### Variance Request Form for Marina Coast Water District

Requested Variance (include District Code Section) Ordinance 3.28 (Cross Connection Control)

Street/Mailing Address for Variance 3055 ZANETTA Dr City MARINA State CA Zip 93933

APPROVED BY DISTRICT ENGINEER		MARINA COAST WATER DISTRICT STANDARD PLAN	STANDARD
DATE 04/2014			REDUCED PRESSURE PRINCIPLE BACKFLOW PREVENTION
		3/4-INCH THROUGH 2.5-INCH

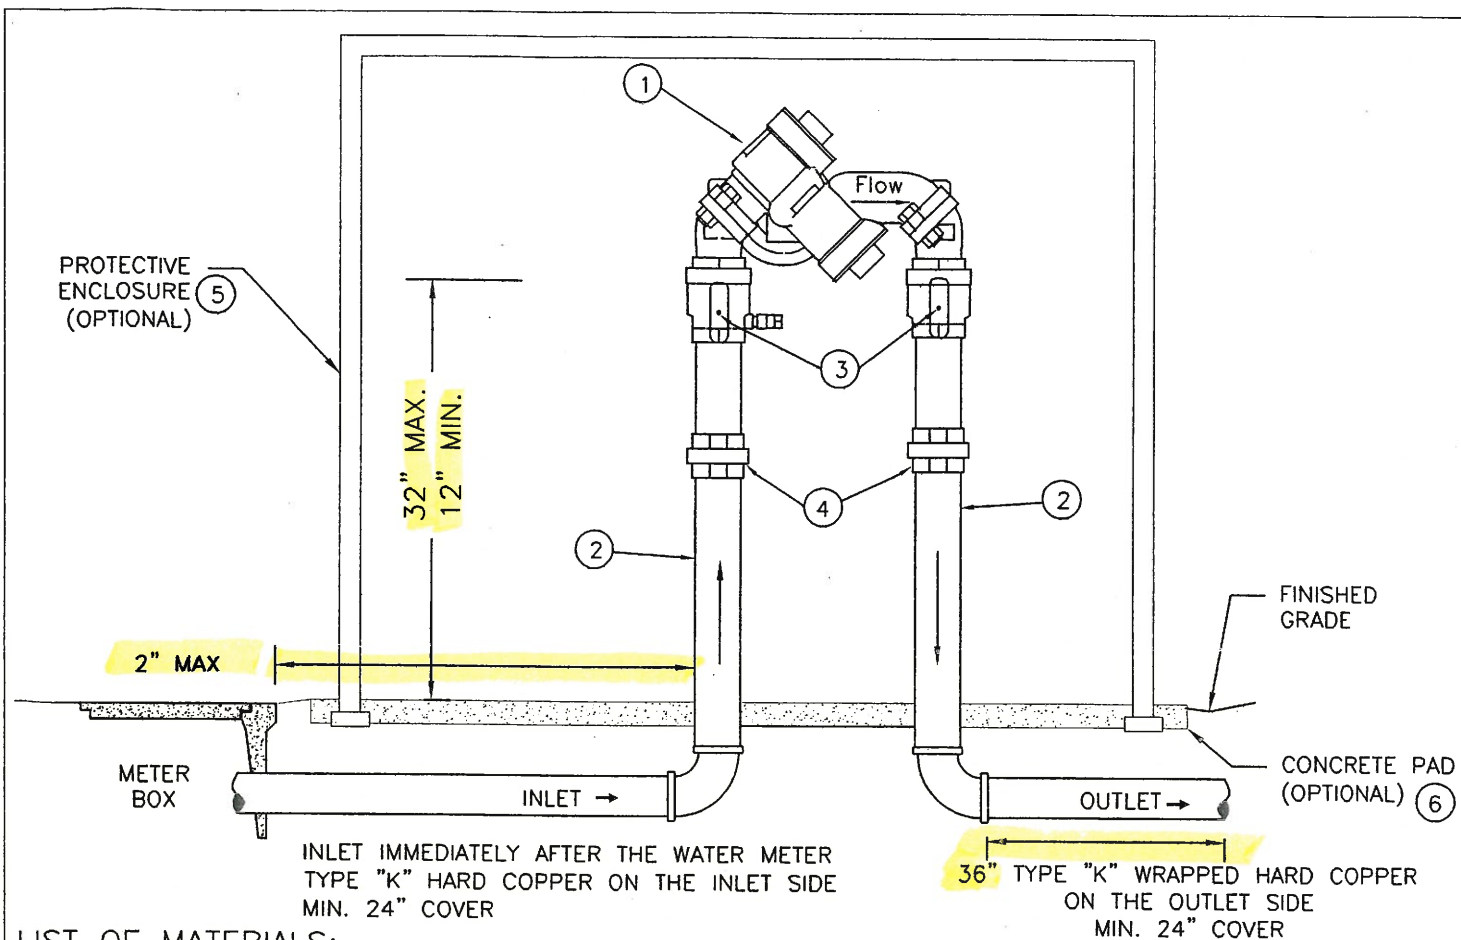
IF I follow The instructions according to the attached Marina Coast Water District Drawing, I would have the pipe and back flow valve stick out from the middle of the dryway, making the dryway impossible to use.

I would like the board to evaluate the possibility of having Marina Coast Water District to put me in the condition to install the backflow valve in accordance to their drawing W-18 avoiding the owner to sustain unfair and undue hardship.

Figure 1

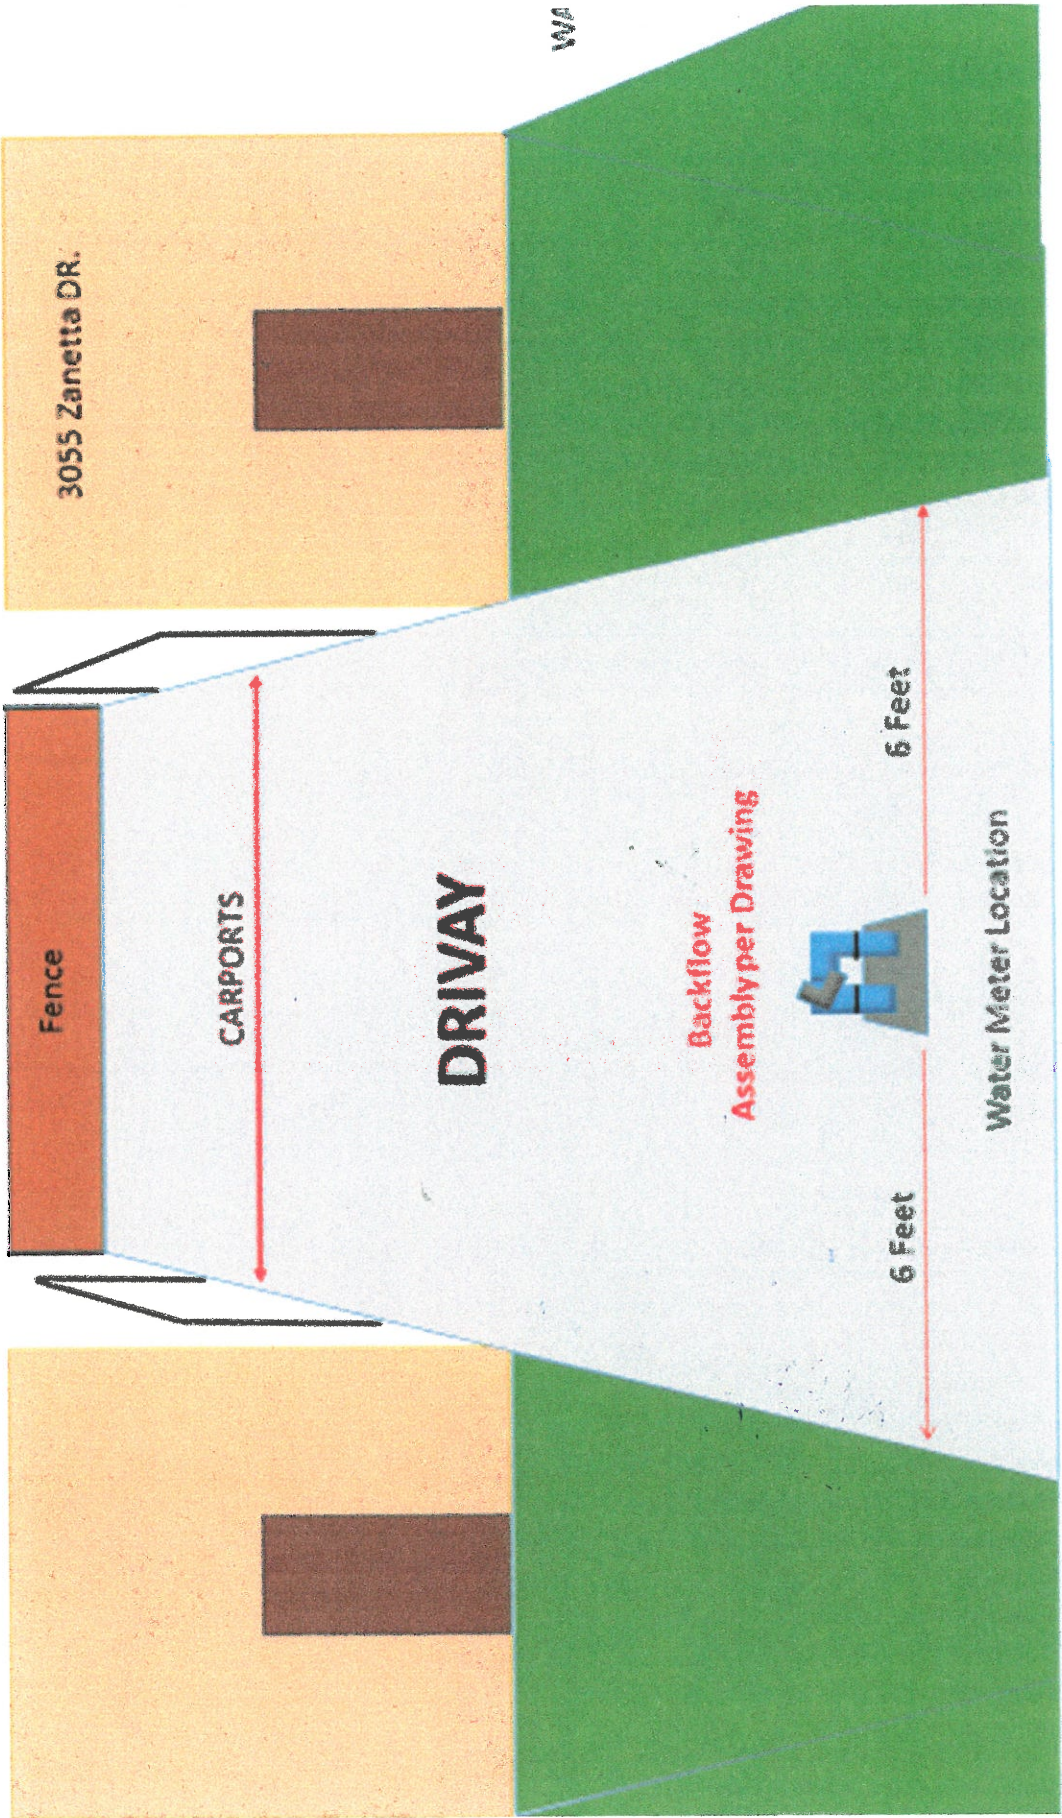
Drawing figure 1 showing how the Backflow valve would look like if installed in accordance to the attached sheet 1 of 1 W-18 Marina Coast Water District drawing.
